**TOWN OF OYSTER BAY
BETHPAGE COMMUNITY PARK
INTERIM REMEDIAL MEASURE - CONSTRUCTION AREA**

ADDENDUM TO THE REMEDIAL ACTION PLAN

MARCH 2006

**Town of Oyster Bay
Department of Public Works**

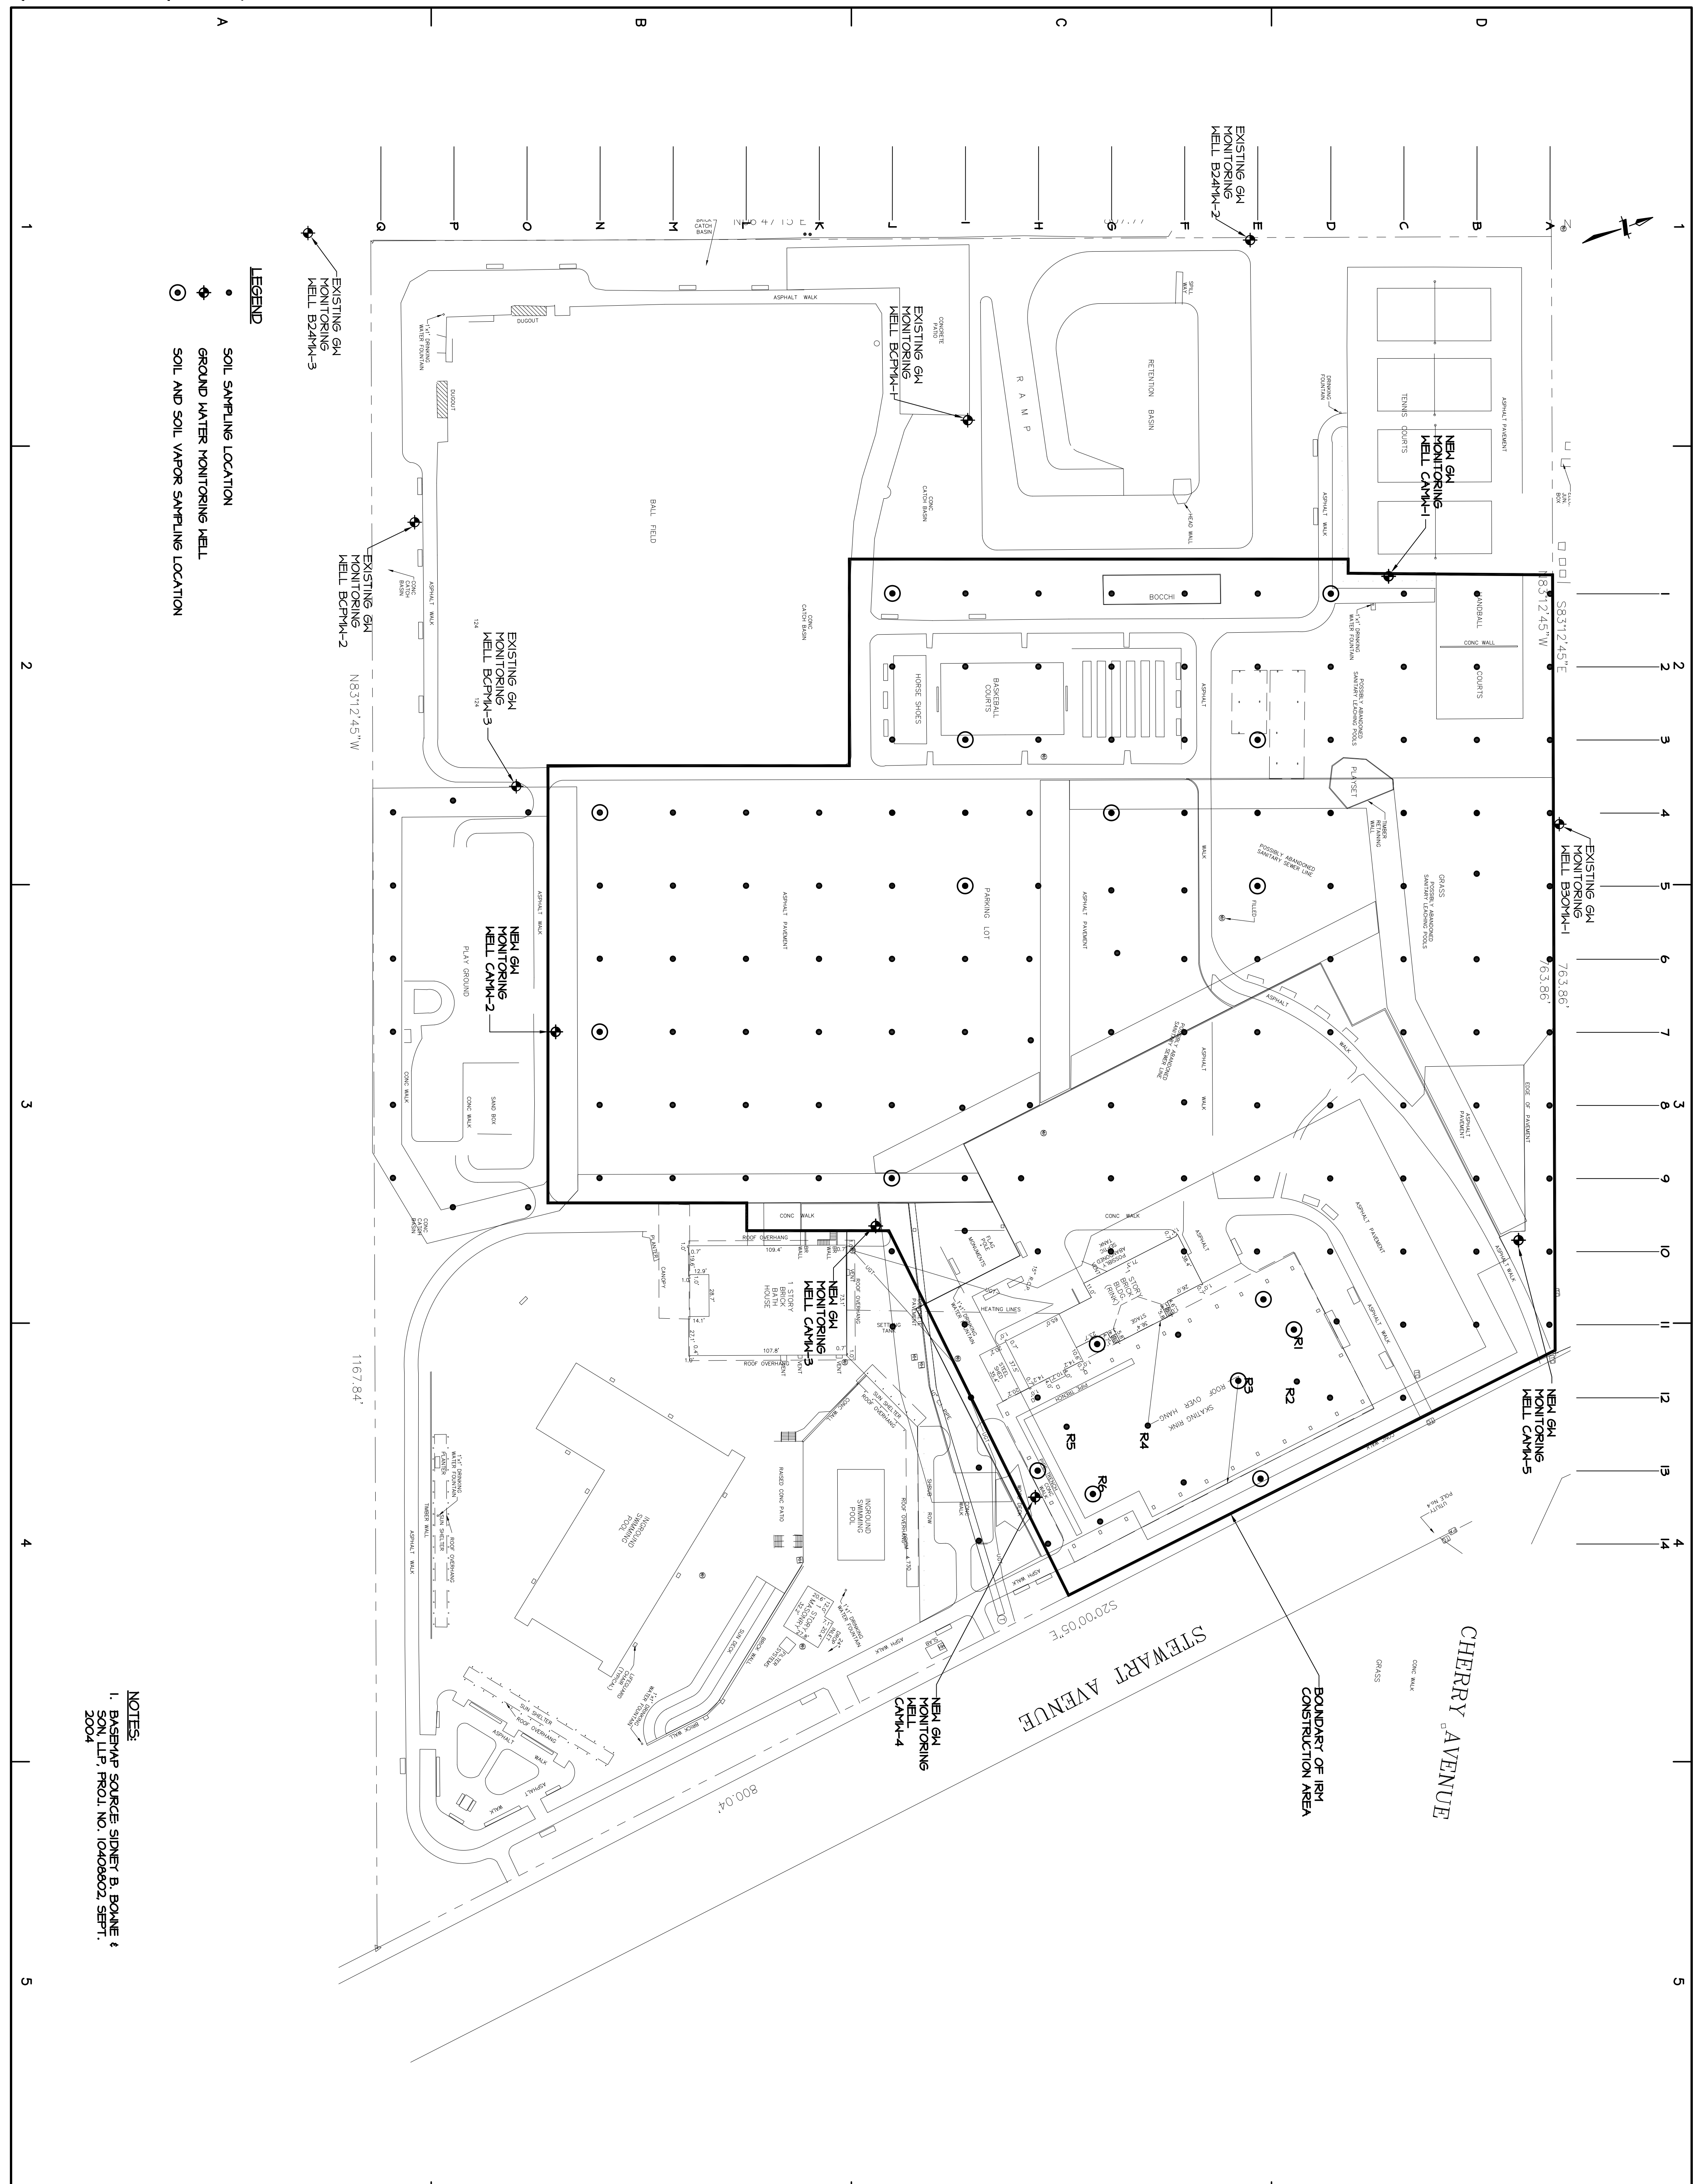
3. Page 10, Last Paragraph: Figure 6 referencing Metal exceedences should read figure 5 here and in all text locations.

Comment 3 - Page 10, Last Paragraph: Figure 6 referencing Metal exceedences should read figure 5 here and in all text locations.

Response to Comment 3: The figure number will be changed in the addendum to the Remedial Action Plan.

**SOIL SAMPLING
RESULTS FOR PCBs,
VOCs AND SVOCs**

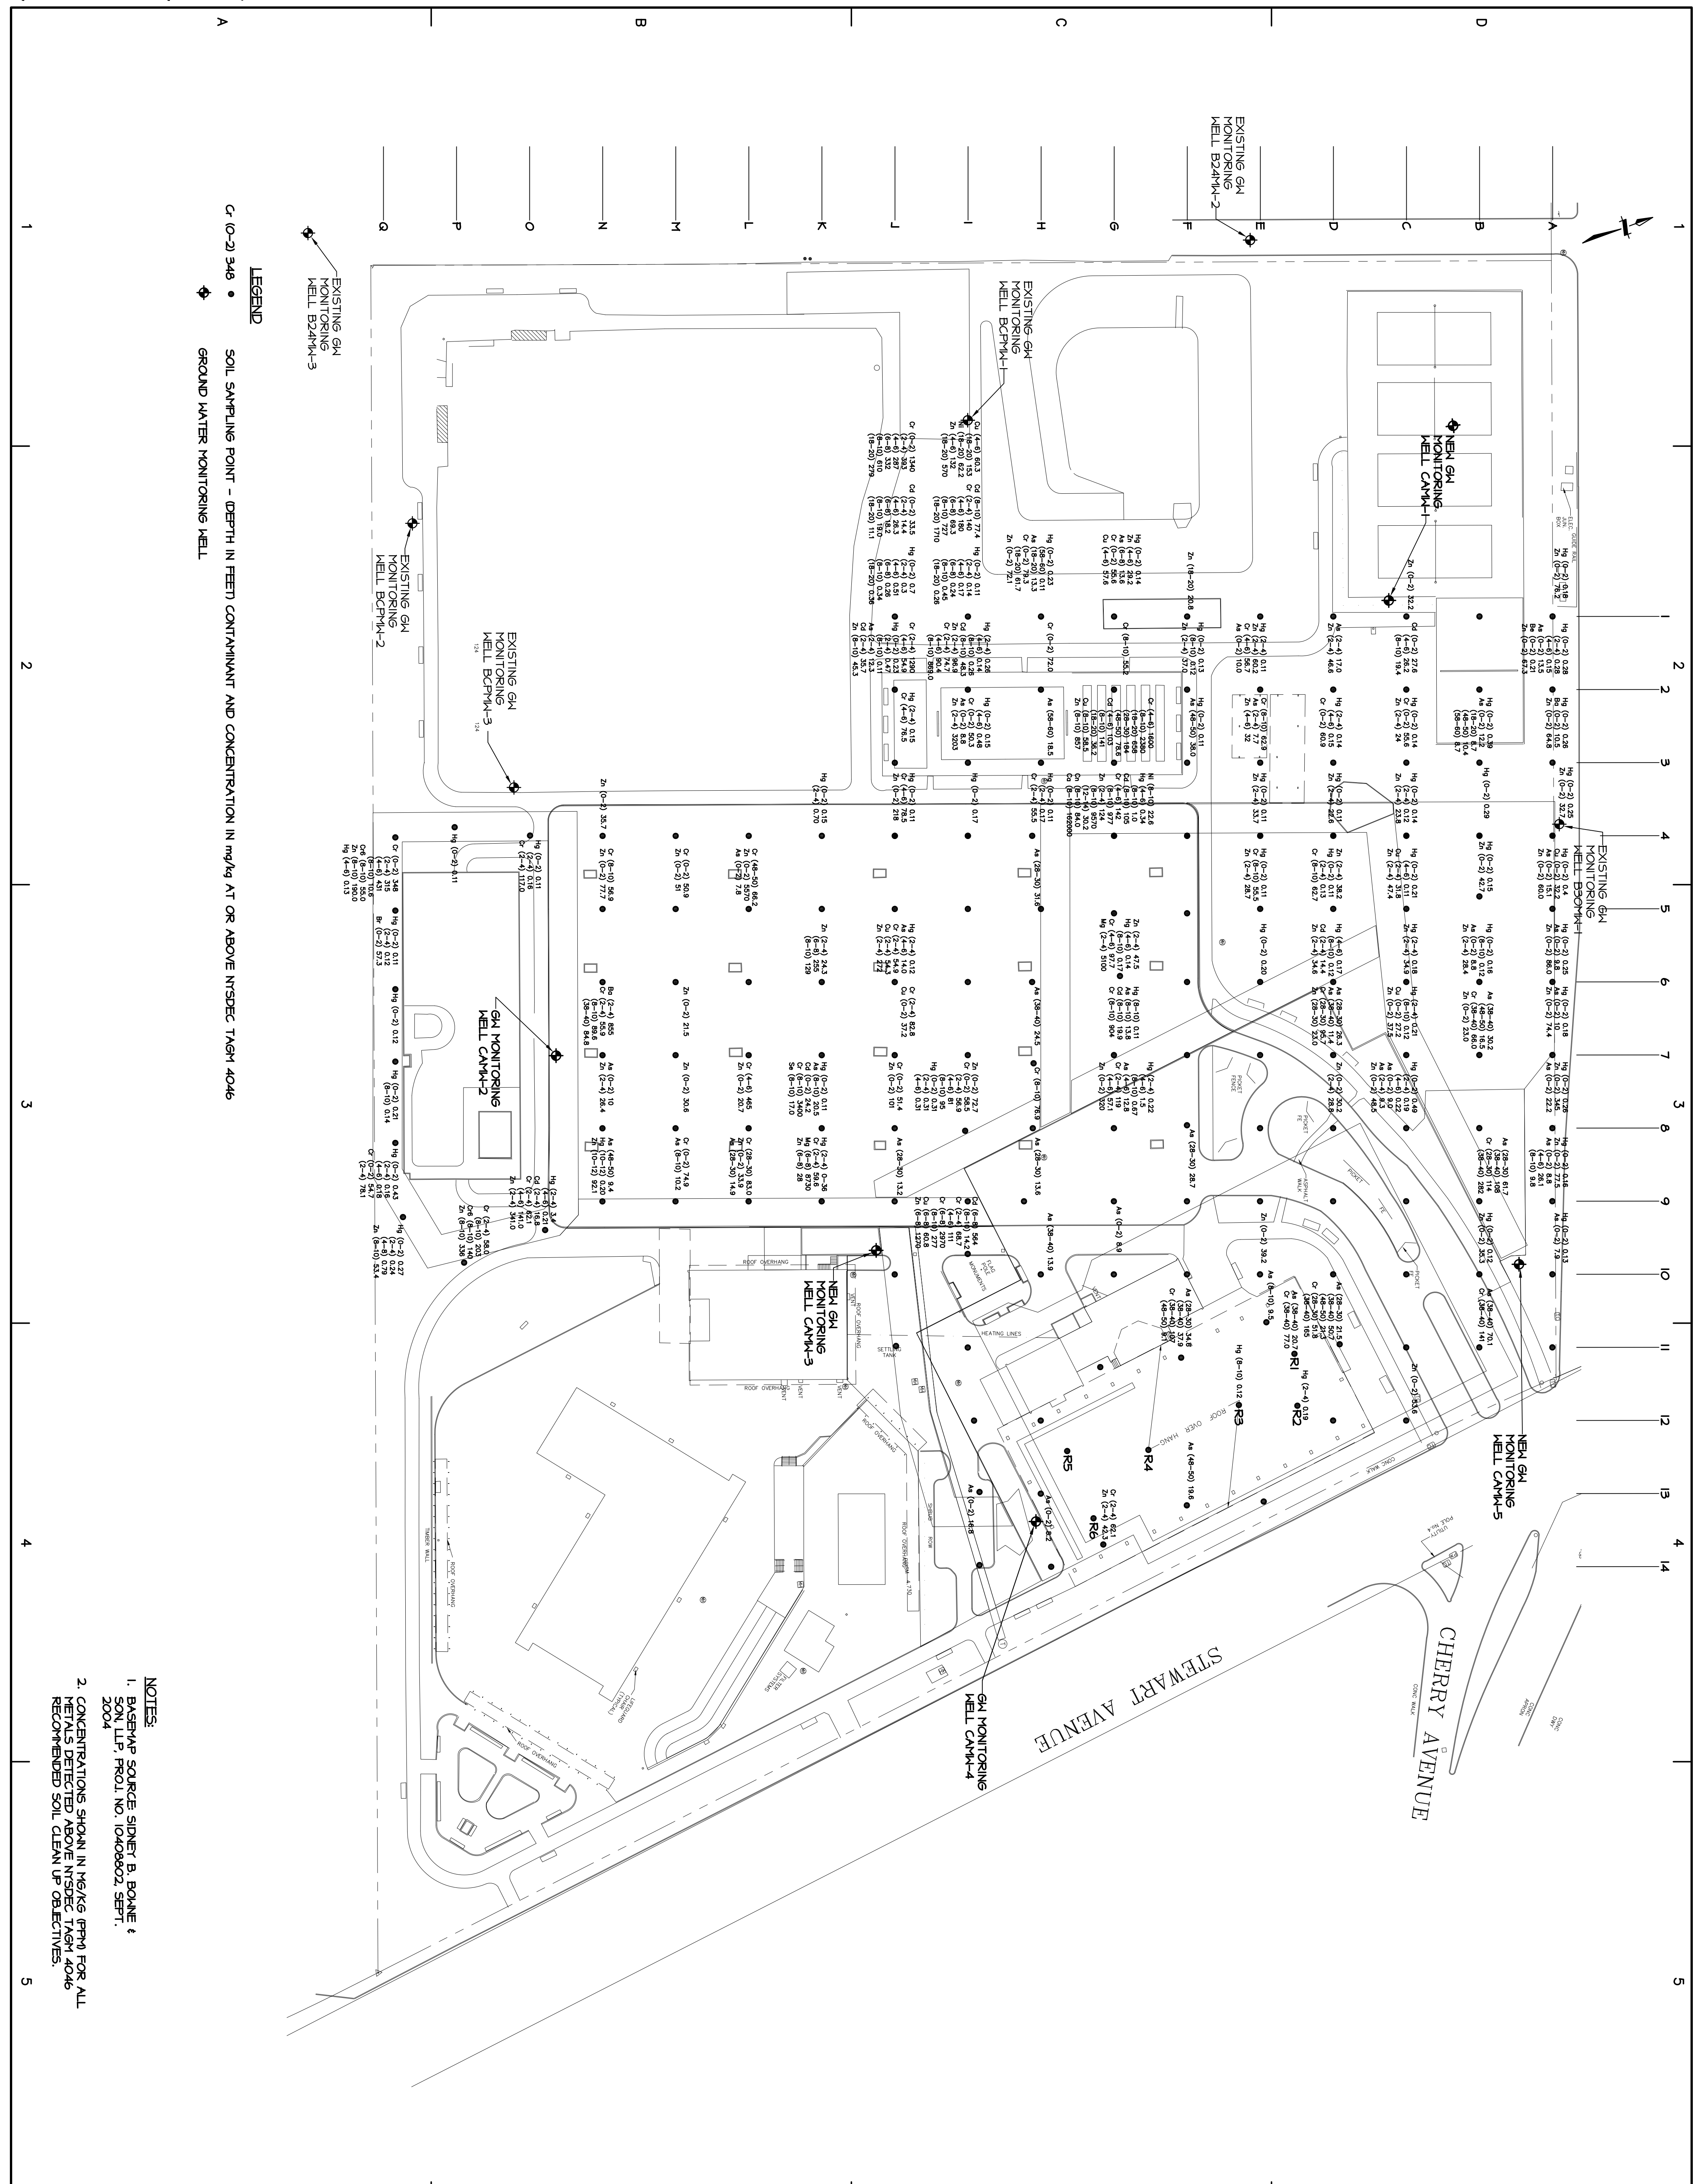
2. Page 10, Third Paragraph: Figure 7 referencing PCBs exceedences should read figure 6 here and in all text locations.

Comment 2 - Page 10, Third Paragraph: Figure 7 referencing PCBs exceedences should read figure 6 here and in all text locations.

surface soils in 31 of the 160 boring locations and exceeded 10 mg/kg in subsurface soils in 9 boring locations. A site plan summarizing PCB soil concentrations above 1 mg/kg, based on the findings of the 11/2005 IR/RAP and 12/2005 SIR, is enclosed as Figure 4. It should be noted that similar figures were included in the 11/2005 IR/RAP and 12/2005 SIR. However, in the 11/2005 IR/RAP, the figure number was incorrectly referenced in the text of the report.

Response to Comment 2: The figure number will be changed in the addendum to the Remedial Action Plan.
